FLOOD RISK ASSESSMENT and DRAINAGE STRATEGY

RESPONSE (2) to MSDC Flood Risk and Drainage Team Further Comments

Class Q Barn Conversions Prior Approval Application

Hammonds Mill Farm Estate Hassocks West Sussex

MAP 1

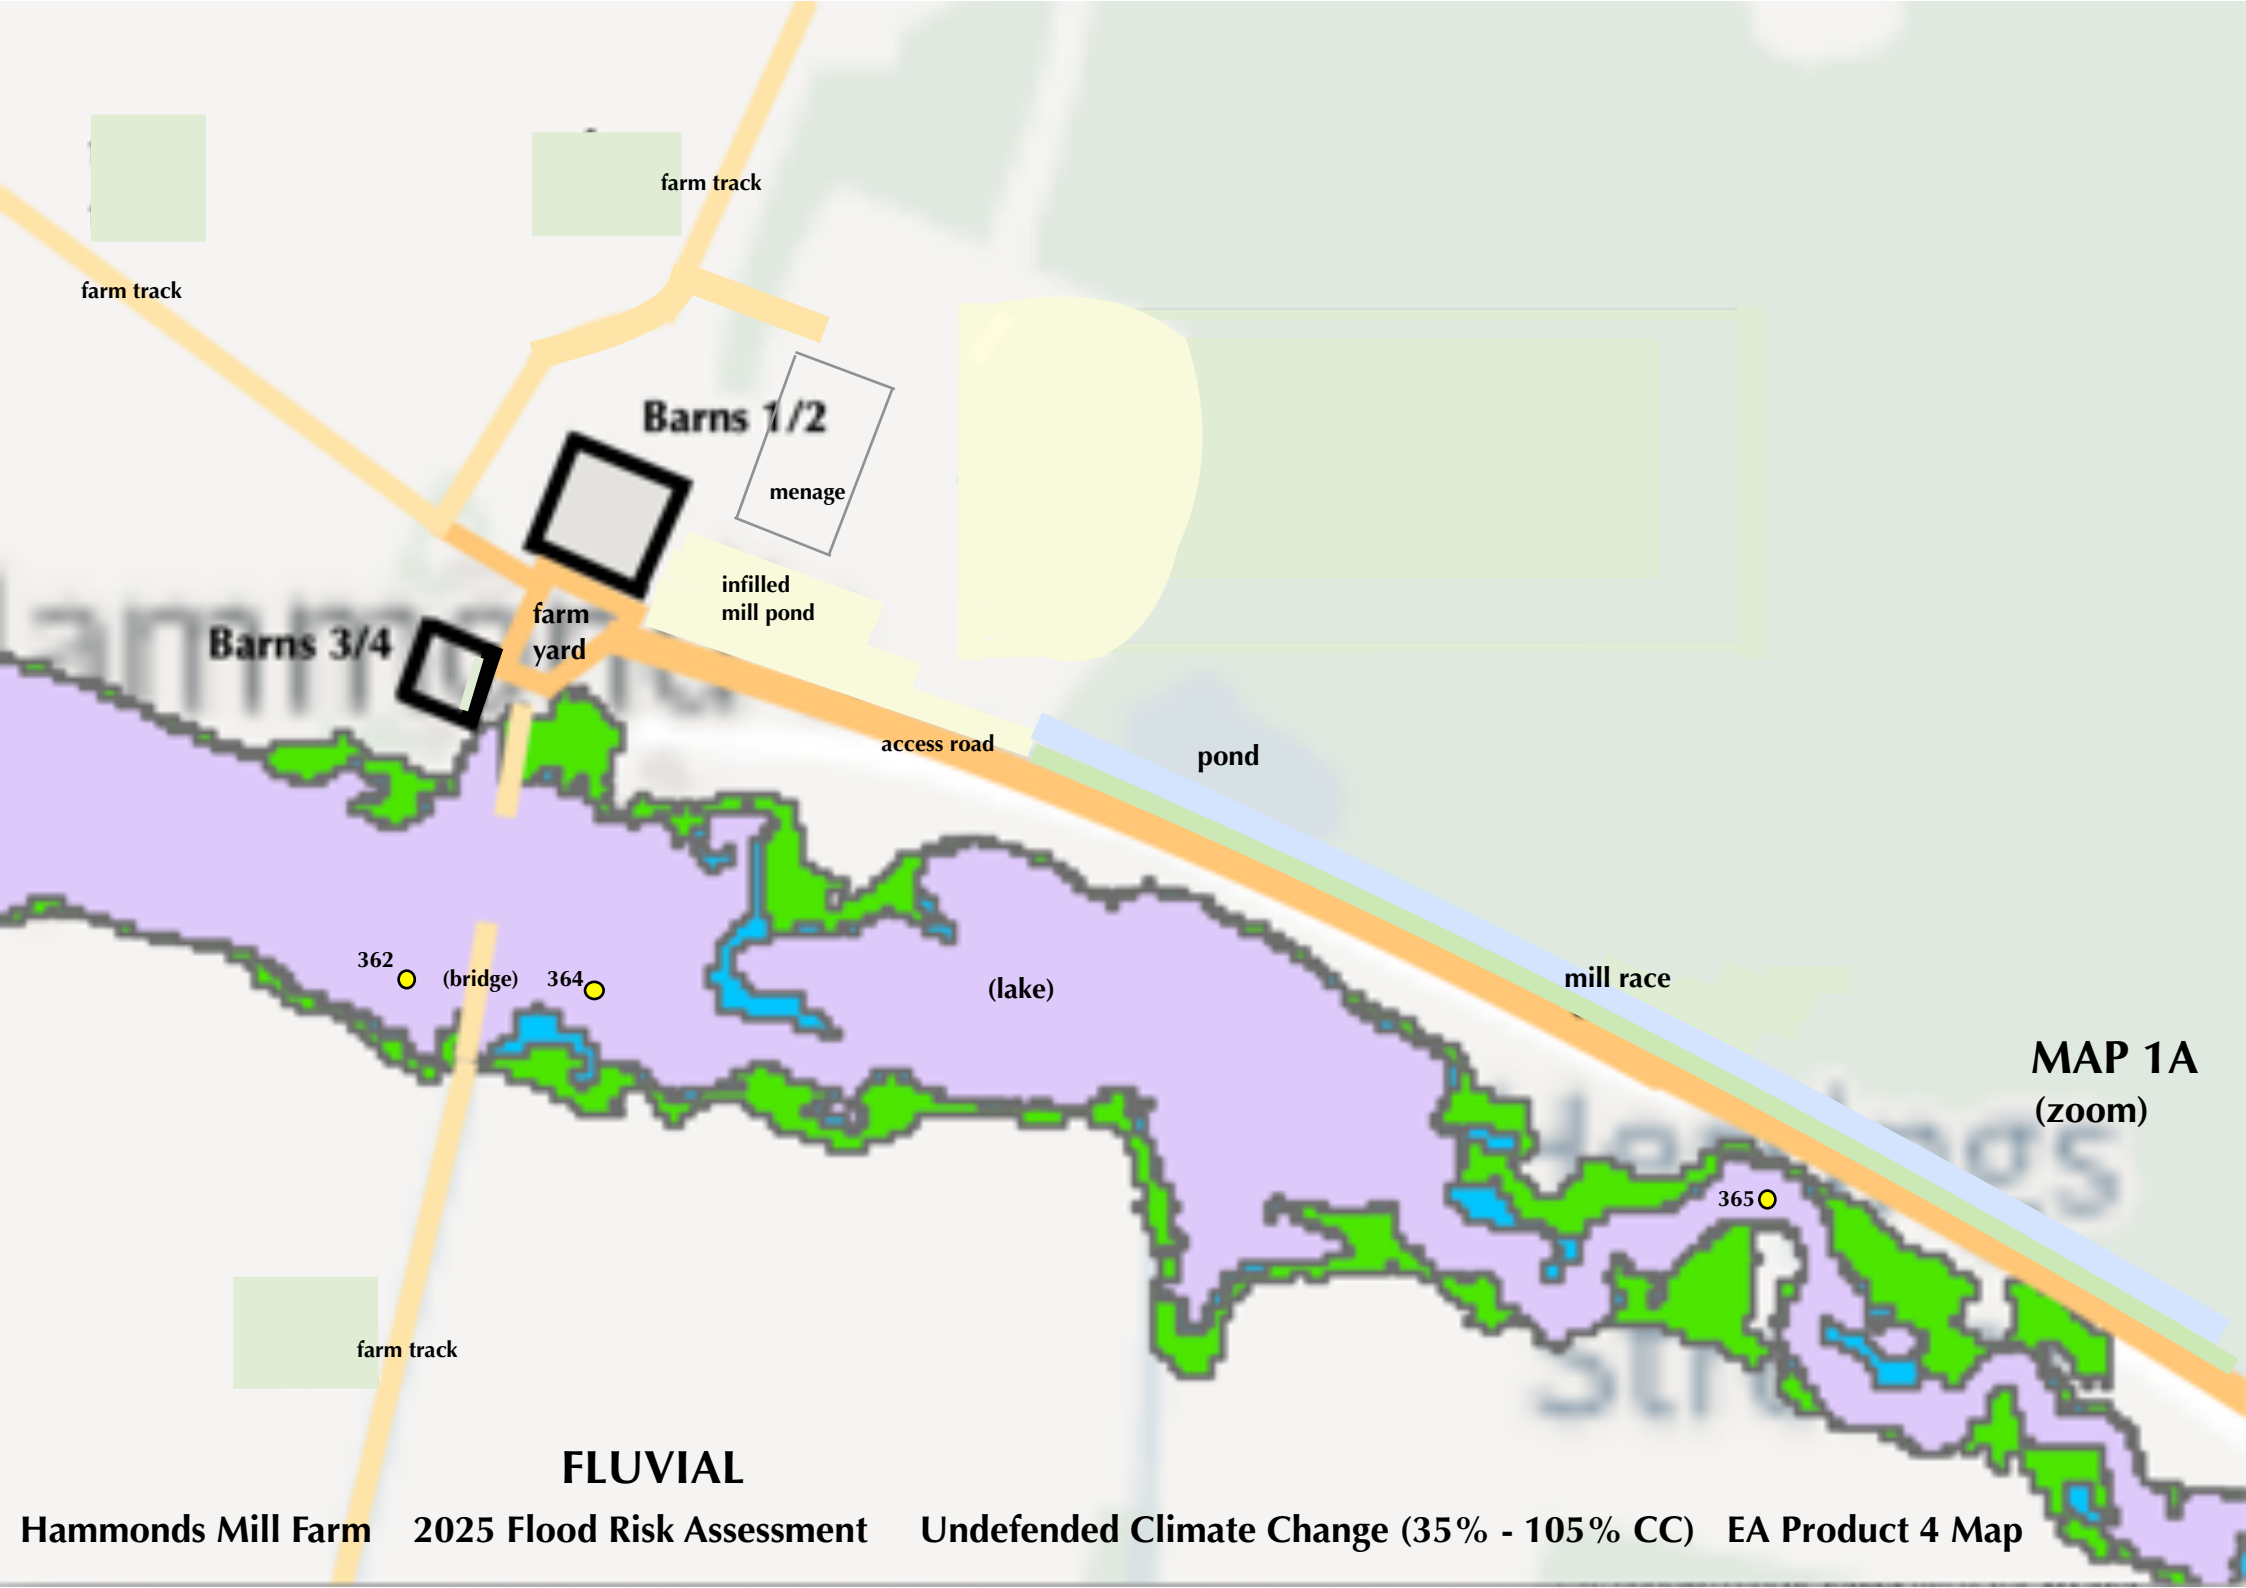
- 1.8 The EA EXTENT mapping with 105 % CC also show that this higher flood extent is mainly to the east of Barn 3, although also a little closer to the south of Barn 3. This is also confirmed from topographical contours and levels.

See Appendices: MAP 1 and MAP 1A, Buildings overlain on EA flood modelled mapping

Hammonds Mill 2025 FRA EA FLUVIAL 1 in 100 + 35% and + 105% CC
flood levels modelled on topographical survey_buildings ZOOMED IN

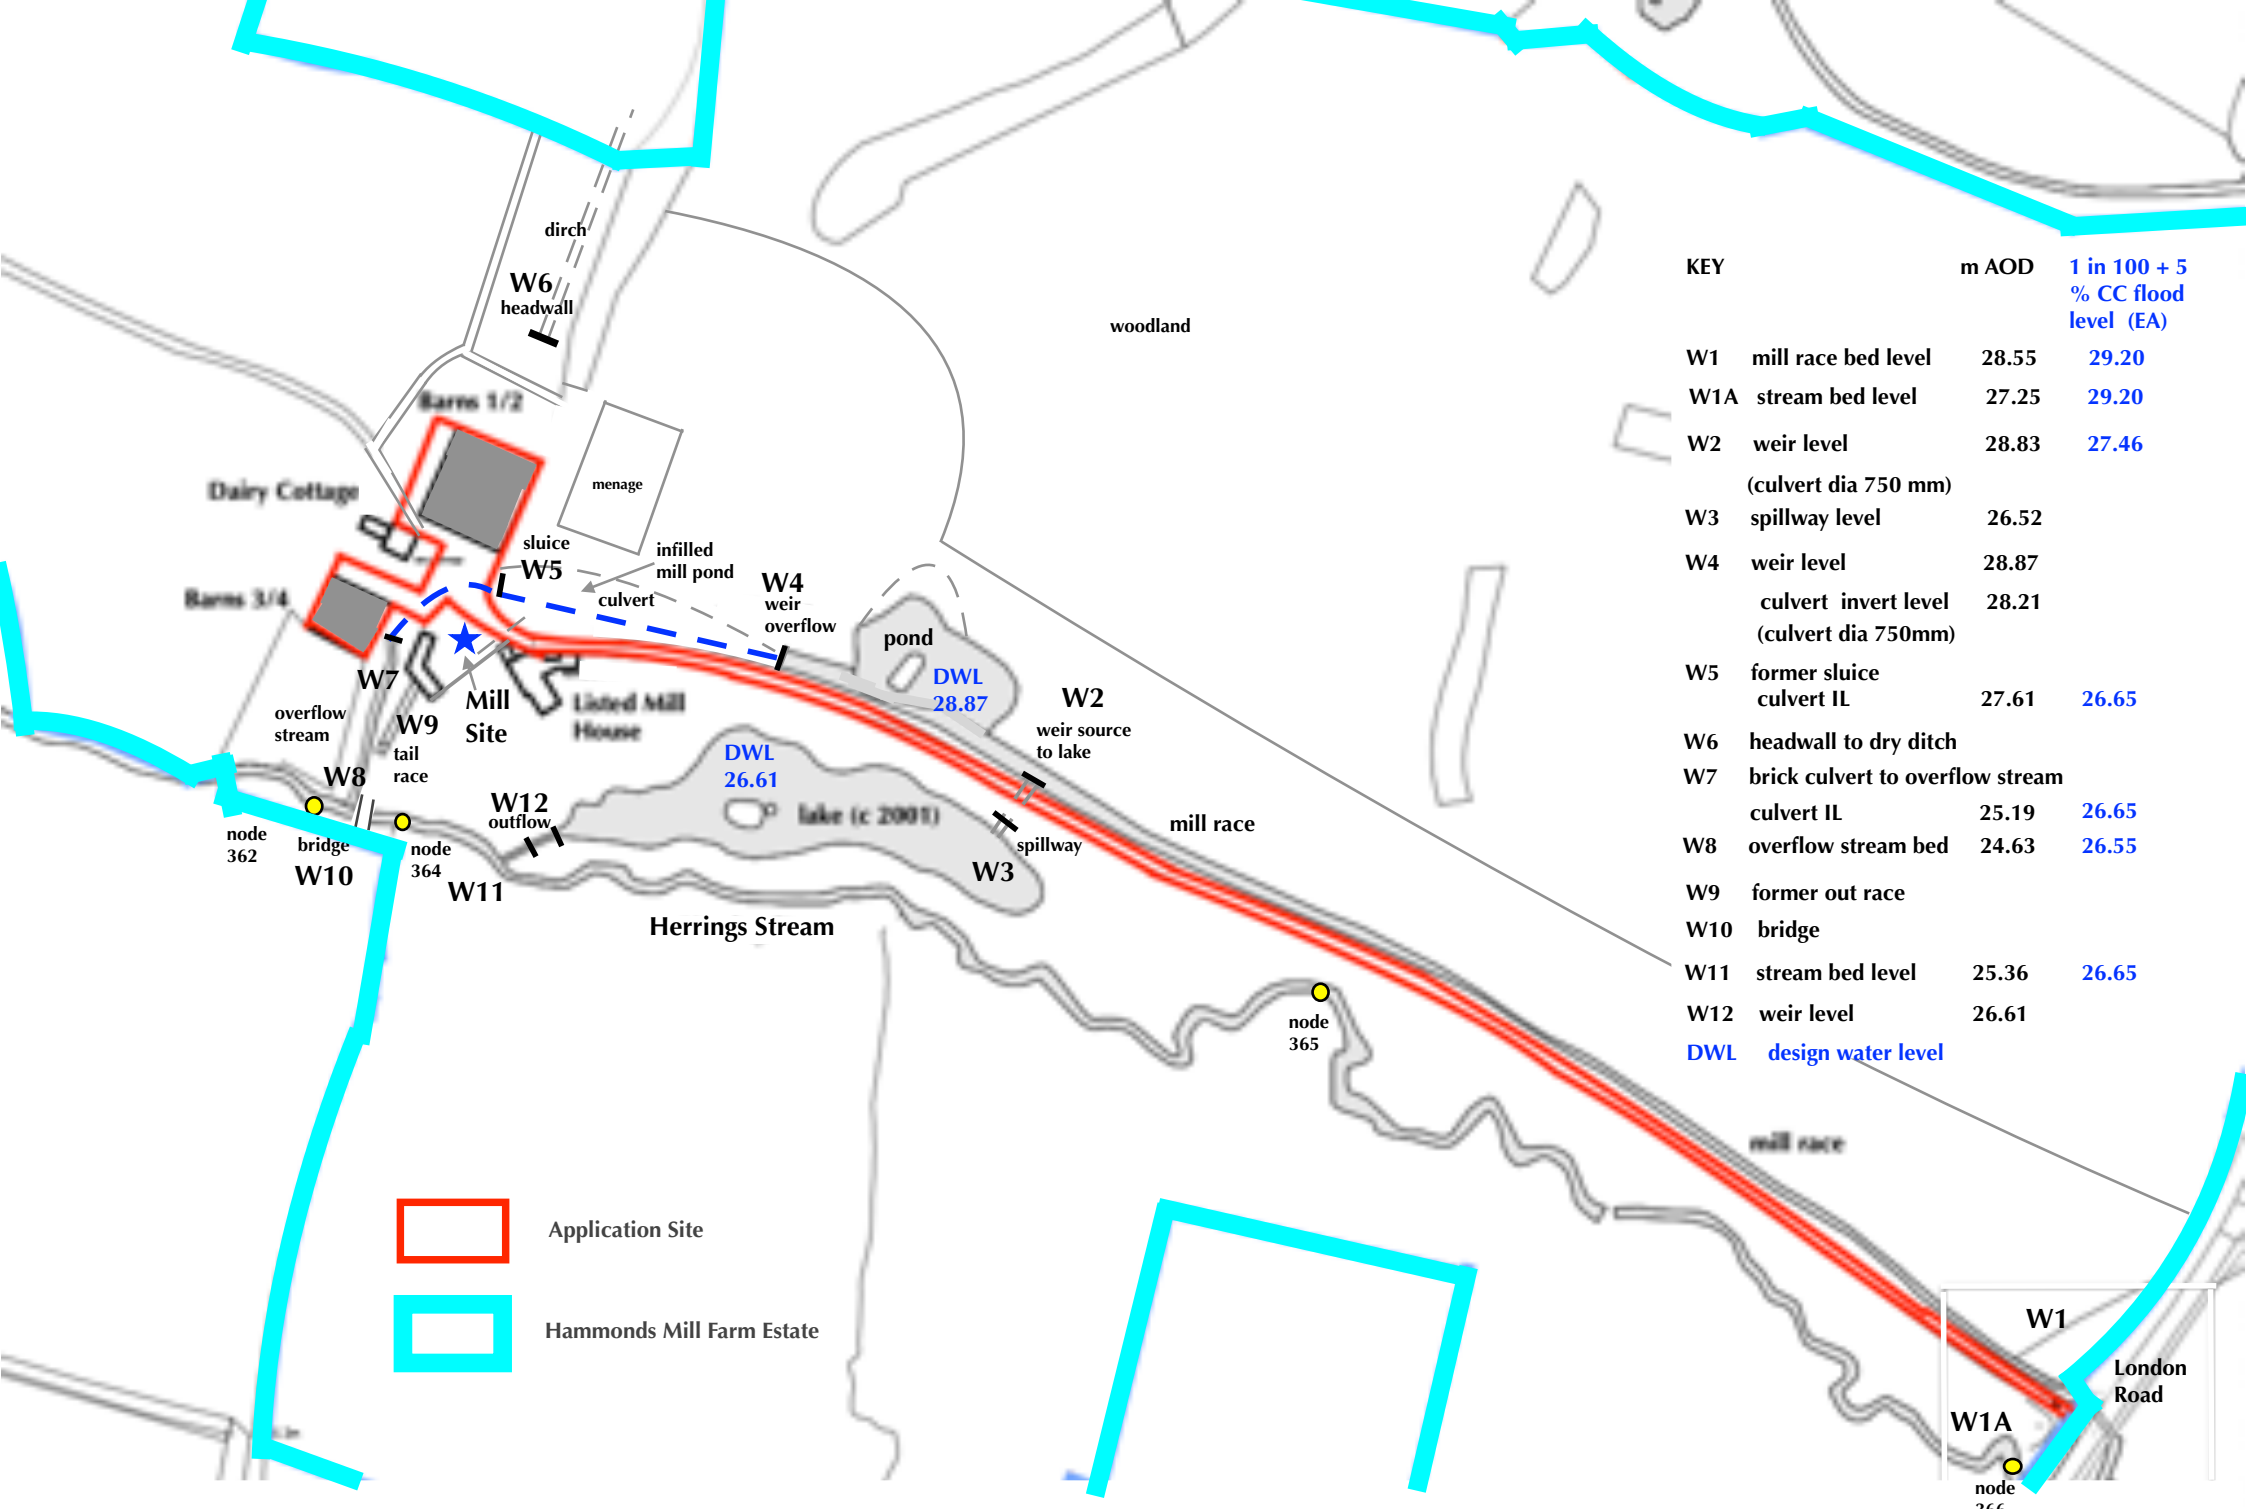
- 1.9 EA Flood EXTENT levels, both 1:100 + 35% CC and 1:100 + 105% CC levels from node 364 are mapped onto the 2025 topographical survey and confirm that a proposed FFL of 27.75m AOD, (existing floor level 27.55) provides a freeboard of 890mm which is more than EA Standing Advice recommends for dwellings with ground floor sleeping space.

- 2.1 The 1:100 + 35% CC flood level (26.65m AOD) and the 1:100 + 105% CC flood level (26.89), using node 364 data, has been clearly mapped onto the 2025 topographical survey, as described in 1.9.

See Appendices: MAP 2, MAP 3

See Appendices: MAP 2, MAP 3

Section at culvert entry to overflow stream
drwg 0264_FRA_S1 revA

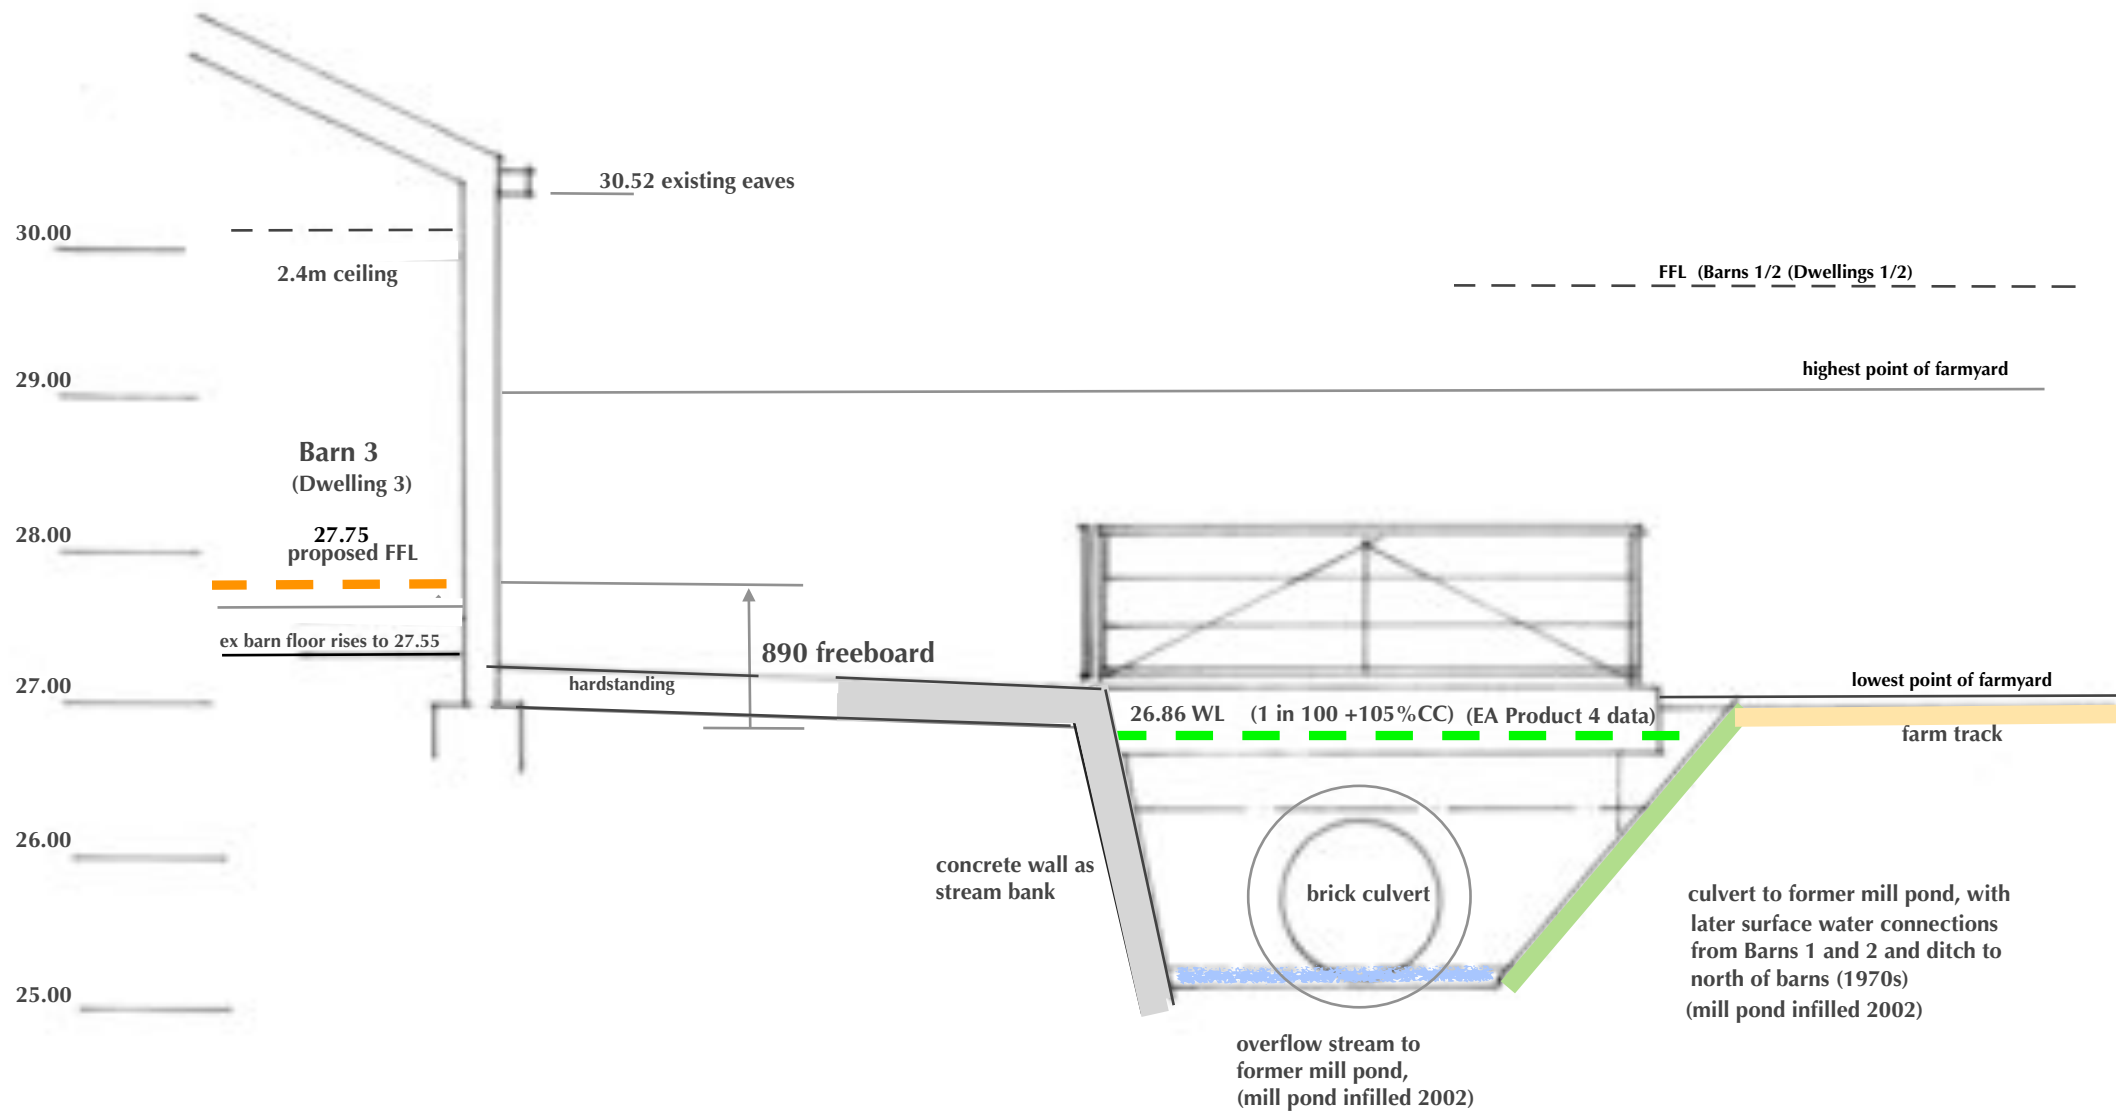
- 1.11 The site sections at Barn 3, included in the updated FRA have been amended to reflect the 27.75m AOD proposed FFL.

See Appendices: Site Section 1, Site Section 2
